TECHNICAL BULLETIN
Bell Helicopter **TEXTRON**

No. 212-04-196

MODEL AFFECTED: 212

SUBJECT: INTAKE SCREEN IMPROVEMENTS

Figure 1 (Sheet 1 of 2)
Screen Assembly
(Isometric view)

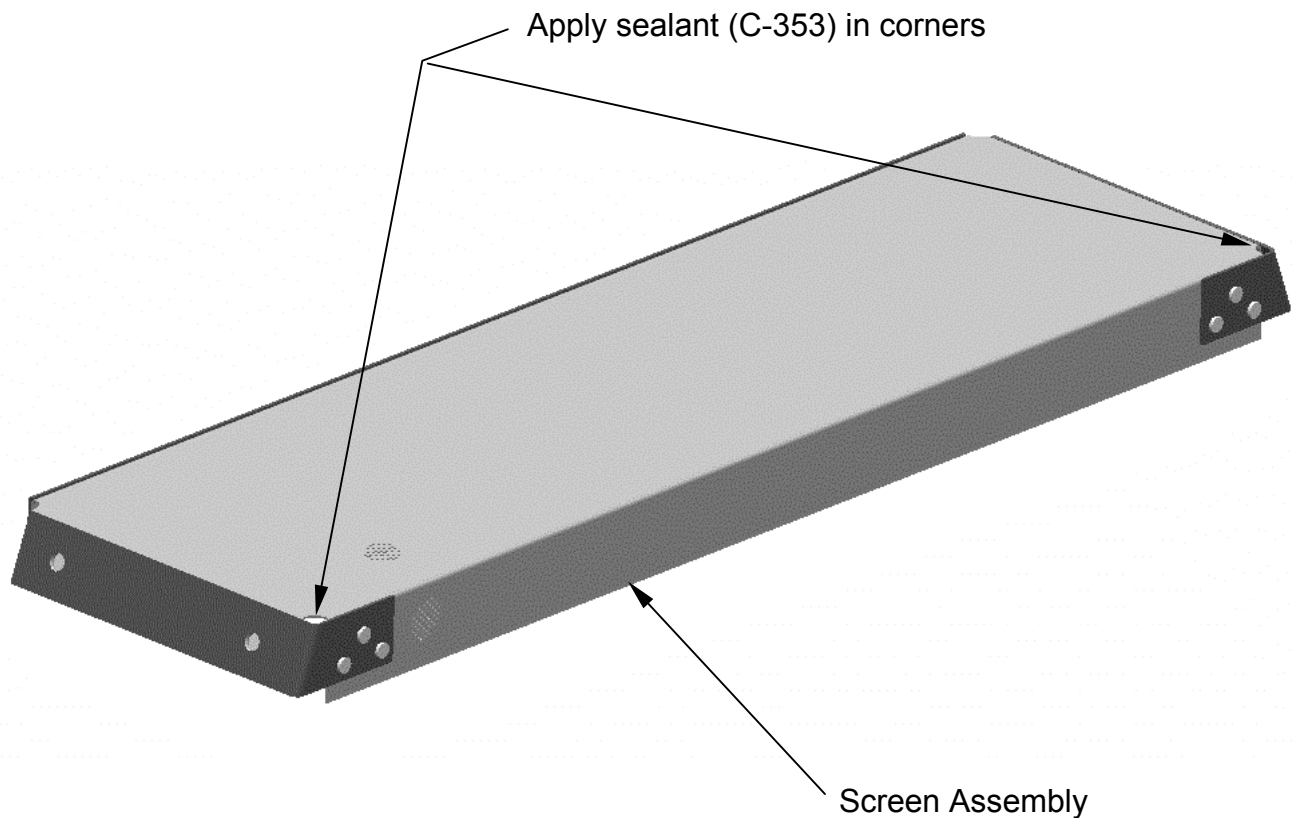
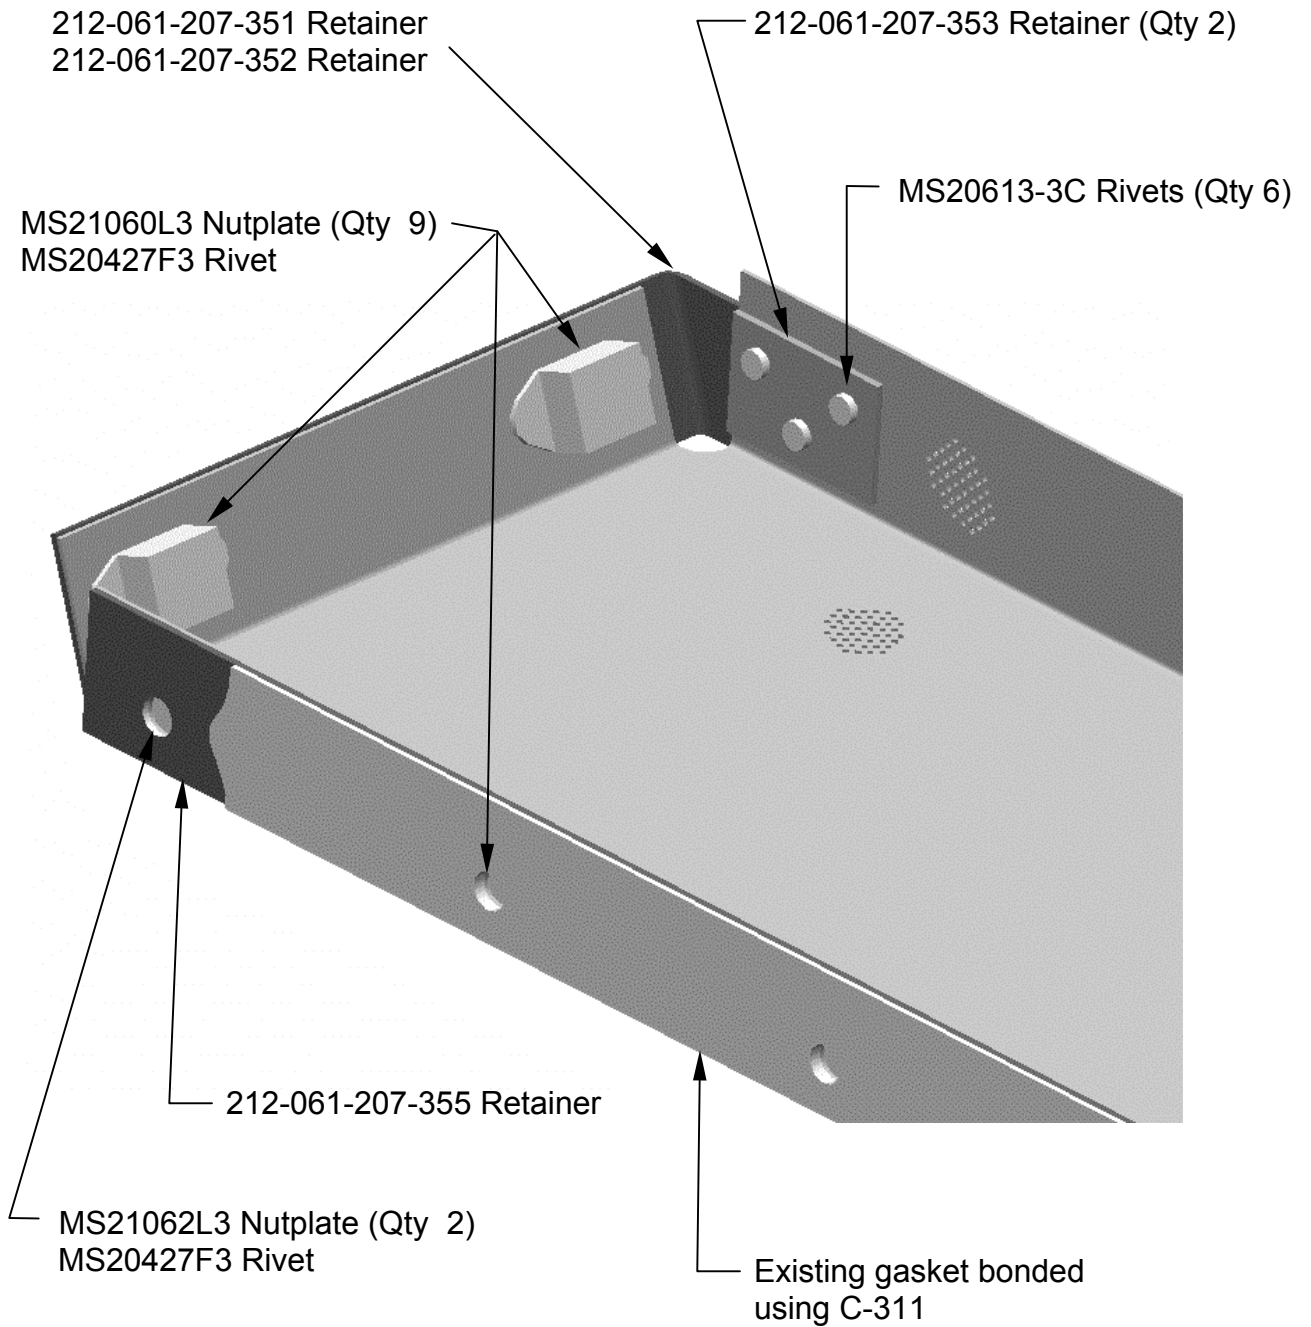
Bell Helicopter has been made aware of corrosion on small clips attached to engine intake screen assembly P/N 212-061-207-035, especially when operating over salt water. These clips were originally made of aluminum. This bulletin describes a procedure to replace the aluminum parts and existing nutplates of the screen with similar parts made of corrosion resistant steel. Alternatively, the new clips may be made locally or the complete screen replaced with the improved one (P/N 212-061-207-349).

4. Remove screens P/N 212-061-207-035 from LH and RH engine intakes.
5. Using a scraper, carefully remove gasket (P/N 212-061-207-061) and retain for reinstallation. Refer to Figure 1.

6. Remove and discard all existing retainers (P/N 212-061-207-097/-098/-099/105) and existing nutplates.
7. Position new retainer (P/N 212-061-207-355) and transfer rivet holes. Countersink nutplate rivet holes and install new retainer and new nutplates using rivets MS20427F3 of appropriate length.

8. Reinstall original gasket using adhesive (C-311).
9. Position new retainers (P/N 212-061-207-351/-352/-353) and transfer rivet holes. Countersink nutplate rivet holes and install new retainers using rivets MS20613-3C of appropriate length and new nutplates using rivets MS20427F3 of appropriate length.

10. Apply sealant (C-353) to fill any void or gap on the screen, specifically in bend relief holes. Allow to dry.

11. Reinstall screens on helicopter using existing hardware on the aft flange and new MS27039C1-06 screws and NAS1149C0332R washers on the side flanges. Reinstall cowlings.
12. Prepare helicopter for flight.
13. Make an entry in helicopter historical records indicating compliance with this technical bulletin.
